**Addendum No: Four (4)**

**Project: College Oaks Elementary – Hurricane Laura Repairs**

**Architect's Project No: HL-010-01**

**Date: January 21, 2021**

**9 ROOF TO WALL AT EXISTING WINDOW**  
SCALE: 3" = 1'-0"

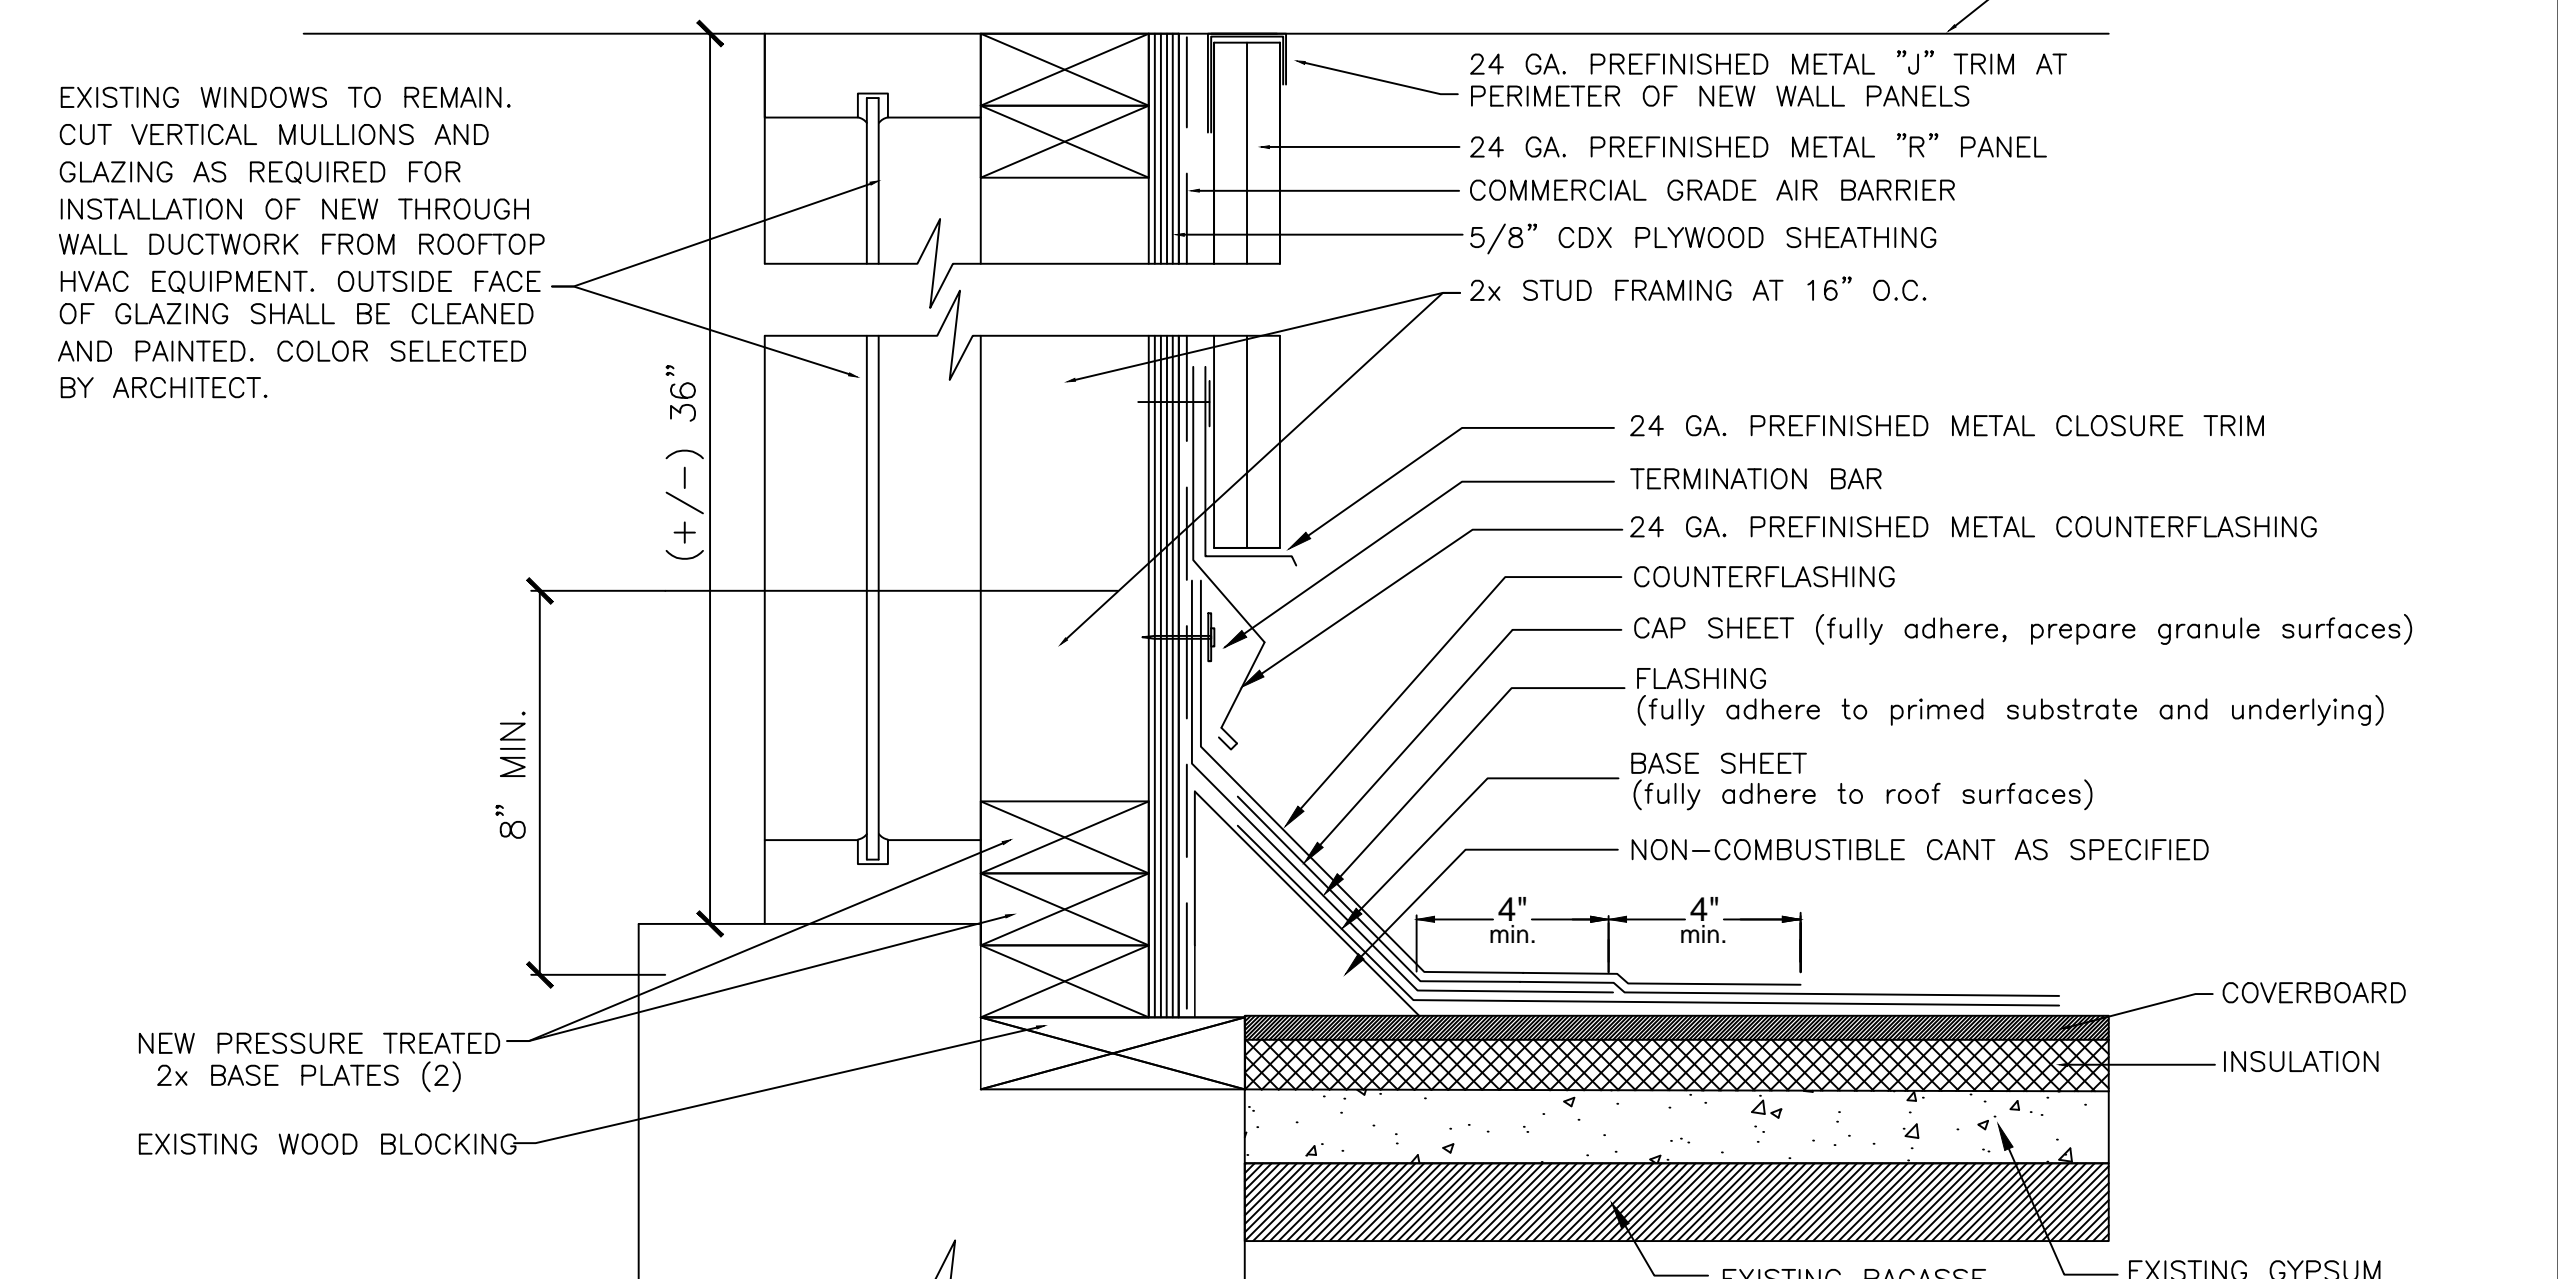
- 7) Sheet A3.1 – Remove existing and replace with revised (See Attached)
- 8) Sheet A3.2 – Remove existing and replace with revised (See Attached)
- 9) Sheets A1.1 & A2.1 – Regarding two (2) temporary buildings to the south of classroom 167 – Contractor shall remove and replace the existing ceiling grid and ceiling tile with new in both (32' x 32') buildings. New ceiling tile shall be Armstrong 1728A 2x2 or approved equal. Contractor shall remove (3' x 3') broken glass window and replace with new. Seal to existing window frame.
- 10) Sheet MP1.1 – Remove and replace with revised (See Attached)

**MP**  
 1.1R

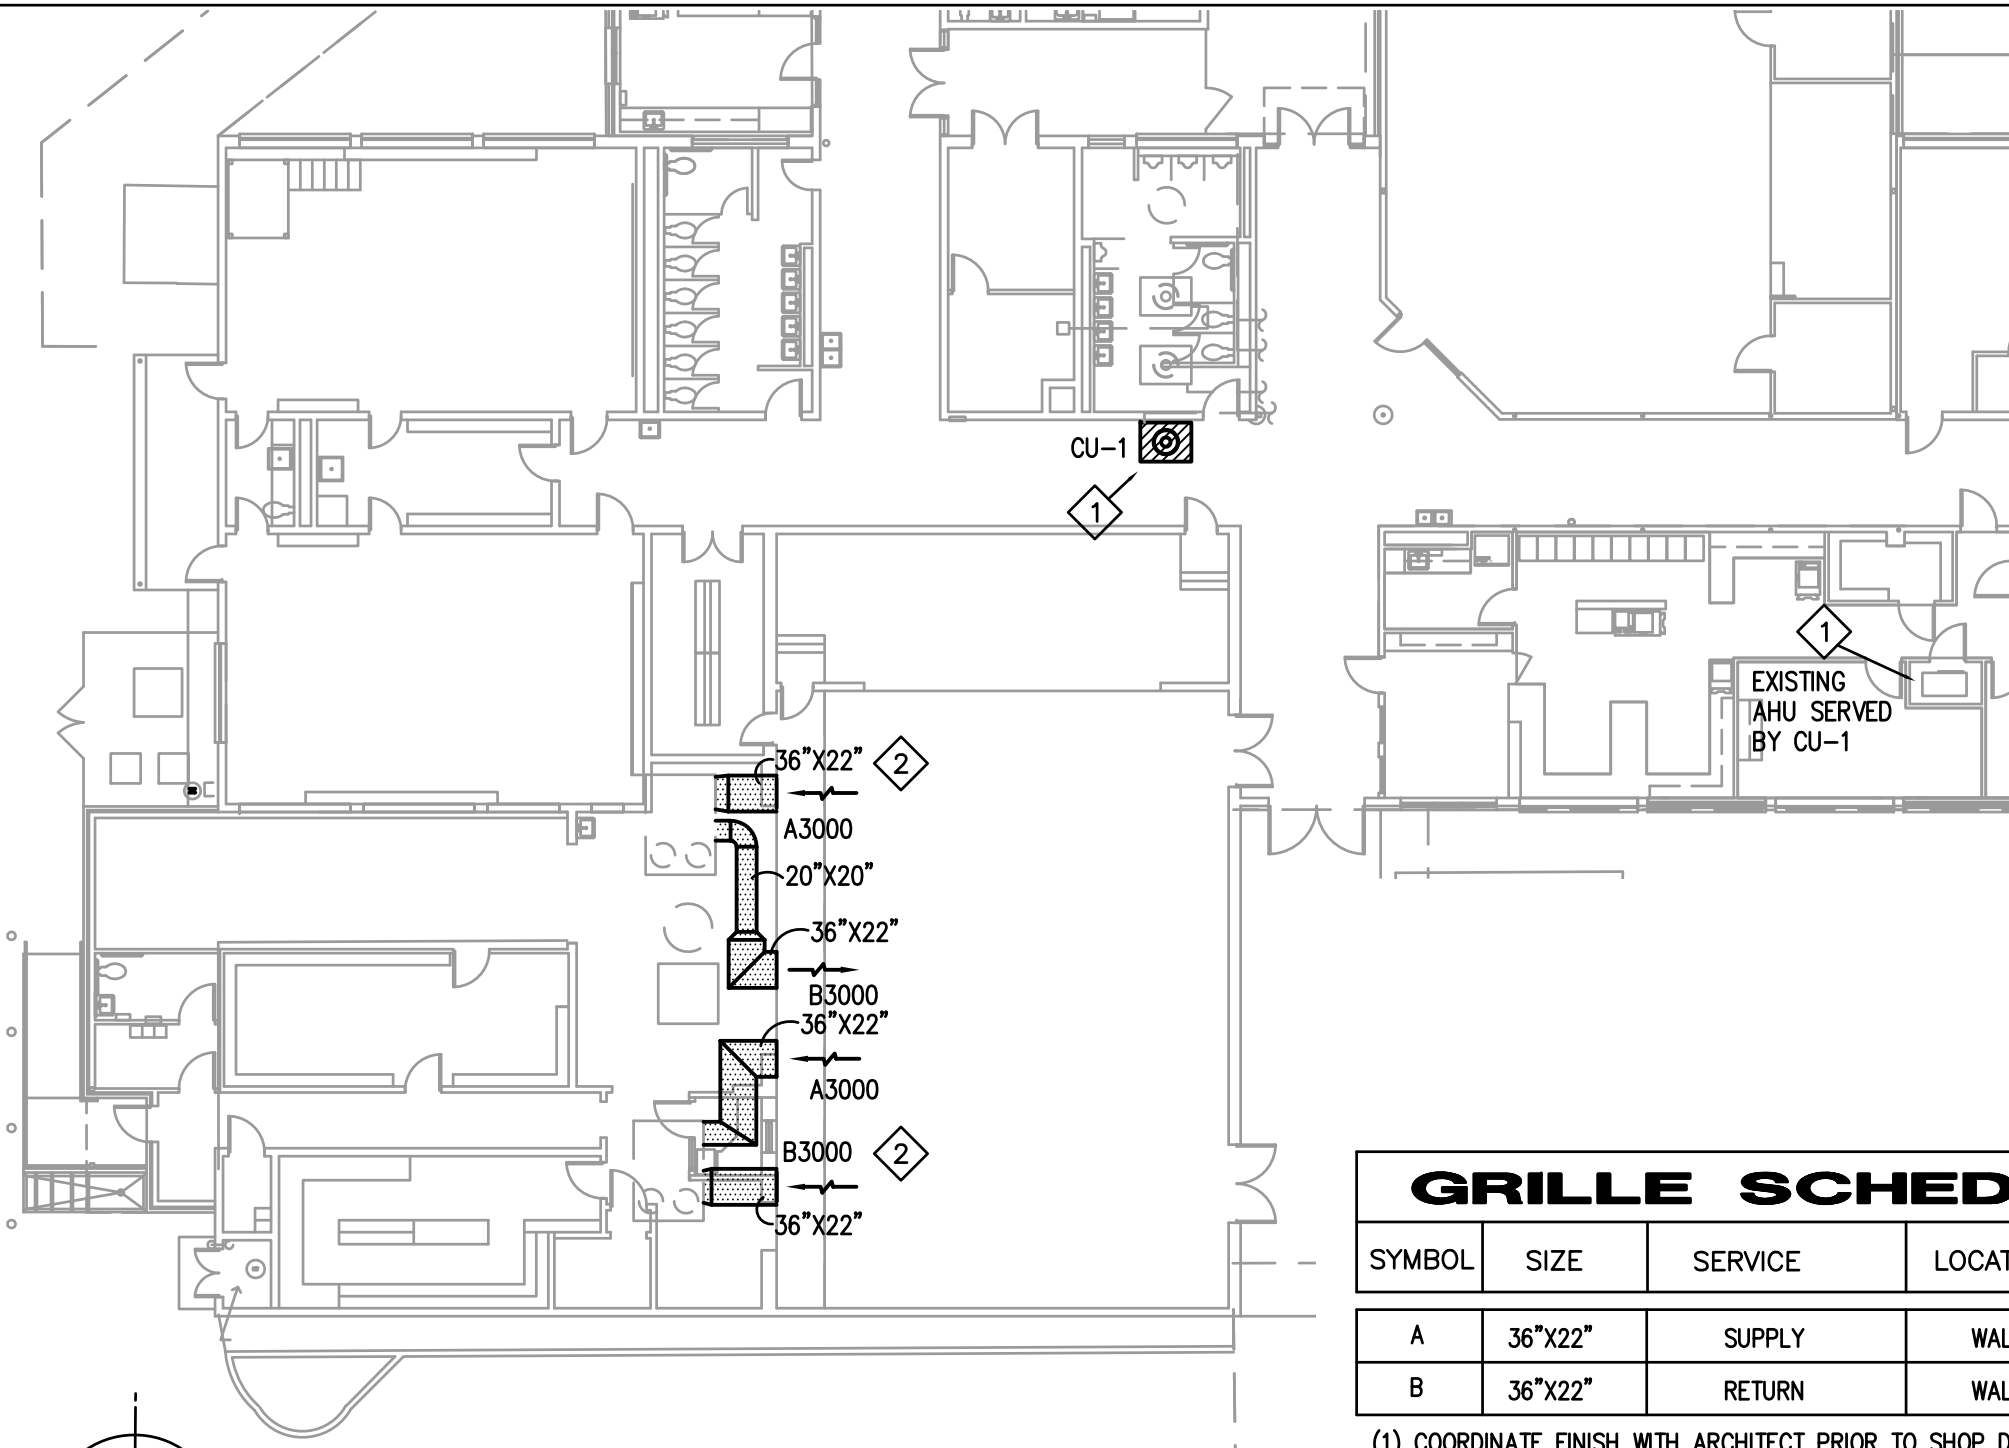
- 11) Ref Sheet MP1.1R (attached):
  - a. Existing condensing R22 unit on roof was discovered to be damaged. Perform work noted on sheet MP1.1R and provide insulated curb and refrigerant line supports as noted on sheet MP1.1.
  - b. Existing duct work serving rooftop packaged units on cafeteria roof shall be removed and replaced as noted in sheet MP1.1R. Work related to packaged units noted on original plan MP1.1 keynote #6 shall be completed as noted.

- a. Disconnect the existing 30A d.s. serving condensing unit scheduled for replacement. Provide and install a new 60-amp 3 p 240v fusible 3R d.s. Tap gutter with 3-#10/#10g/3/4" c and run liquidtite metallic flex to new condensing unit. Provide new fuses matching the equipment nameplate.

- 1 REMOVE DAMAGED EXISTING R22 ROOFTOP CONDENSING UNIT AND REPLACE WITH NEW R410A TRANE MODEL 4TTA4060 OR APPROVED EQUAL. 240/3/60 ELECTRICAL SERVICE, 16.95A FLA, 14 SEER. FLUSH EXISTING REFRIGERANT LINES AND REPLACE EXISTING THERMOSTATIC EXPANSION VALVES. CONDENSING UNIT SERVES EXISTING INTERIOR TRANE TWE060A300EL AHU IN FRONT OFFICE. MODIFY EXISTING REFRIGERANT LINES AS REQUIRED TO CONNECT TO NEW CONDENSING UNIT. VERIFY EXACT LOCATION AND ELECTRICAL SERVICE IN THE FIELD. COORDINATE WITH ELECTRICAL.

- 2 REMOVE EXISTING DUCTWORK AND PROVIDE NEW AT OUTER DIMENSION SHOWN WITH MIN R-12 3" JOHNS MANVILLE LINACOUSTIC OR APPROVED EQUAL INTERNAL INSULATED LINING INSTALLED PER MANUFACTURE'S INSTRUCTIONS. PROVIDE ROOFTOP SUPPORTS. COORDINATE ROOFTOP SUPPORTS WITH ROOFING CONTRACTOR TO MAINTAIN ROOF WARRANTY. DUCTWORK IS TO PENETRATE BETWEEN EXISTING WINDOW MULLIONS. COORDINATE EXACT ROUTING AND DIMENSIONS WITH NEW ROOF HEIGHT, EXISTING STRUCTURE, EXISTING ROOFTOP FANS, AND EXISTING UNIT CONNECTIONS. PROVIDE NEW SUPPLY AND RETURN GRILLES AS SCHEDULED. SEAL DUCT PENETRATION BETWEEN WINDOW MULLIONS AIR TIGHT. COORDINATE SEALING OF WINDOW WITH GC AND ARCHITECT'S PLANS.
